Smithsonian Institution
Office of Facilities Engineering and Operations
750 9th Street N.W., Suite 5200
Washington DC 20560-0908

BUILDING NAME	670 MT. HOPKINS ROAD AMADO, ARIZONA		
PROJECT TITLE	VERITAS PROTOTYPE FDN.		
USED PROJECT NUMBER	0382102		
A/E PROJECT NUMBER	M3 PN02260		
DRAWING TITLE	FOUNDATION PLAN		
DRAWING TYPE	STRUCTURAL DETAILS		
WORKING STAFF	DN	AC	DN
DESIGNED BY	DN	AC	DN
CHECKED BY			
SHEET NO.	S	0	1
OF	DISCIPLINE	TYPE	SEQUENCE

FOUNDATION SITE PLAN
SCALE: 1 : 200

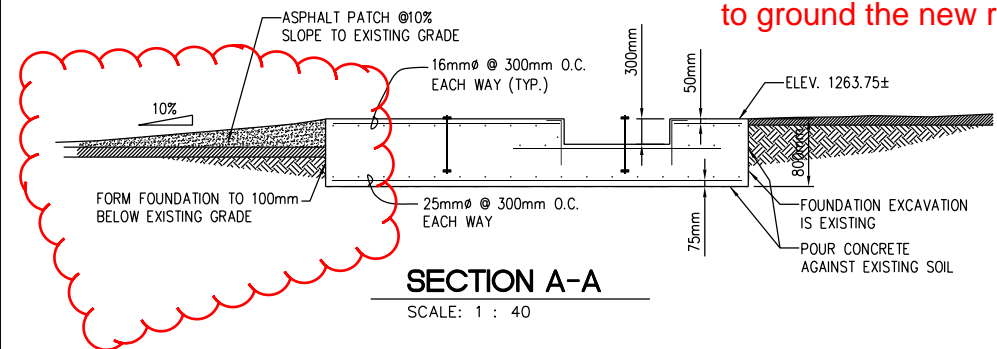
Revise Foundation design (CTA -10-7-1) to accommodate slope? Do we we need to ground the new rebar using this spec?

SECTION A-A
SCALE: 1 : 40

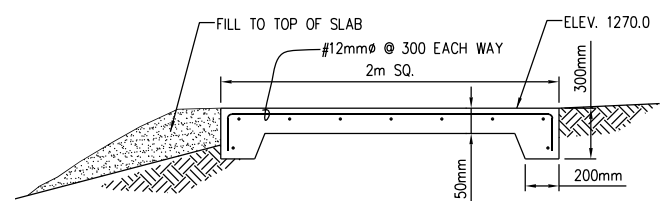
Revise Foundation design (CTA -10-7-1) to accommodate slope?

FOUNDATION PLAN
SCALE: 1 : 30

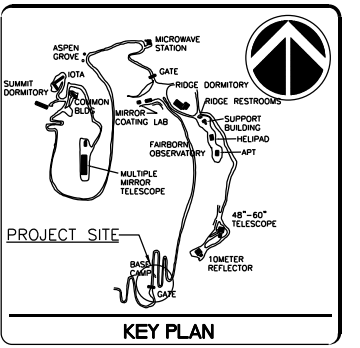
There is a possibility that the grounding system may be disturbed or damaged while doing the excavation, etc.

Do we we need to ground the new rebar using this spec? Repull grounding cable to base of pedestal?
